# SERVICE BULLETIN

TS-120S

#831

SUBJECT: TS-120S ANT INPUT TRANSFORMER REPLACEMENT

TS-120S Ant Input Transformer Replacement: New Part

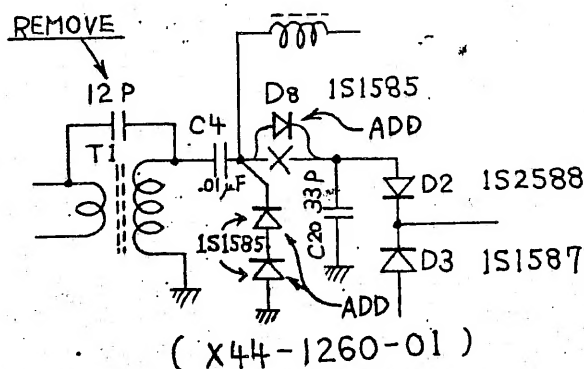
Transceivers subject to strong static fields, high RF, or similar high current atmospheric discharges may suddenly exhibit low sensitivity on all bands. TX will not be affected. Suspect T1 on the RF unit, X44-1260-01.

When replacing T1, L43,0696-35, check that the value of C20 is 33pf. Early units may have a 15pf for C20, and may have T1 as L43-0696-05. In either case, replace the transformer with an L34-0929-15. If C20 is 15pf, replace it with a 33pf capacitor. Since T1 is a broadband transformer, no adjustment is necessary.

In addition, add two 1S1587 diodes after the transformer as shown to further protect the receiver.
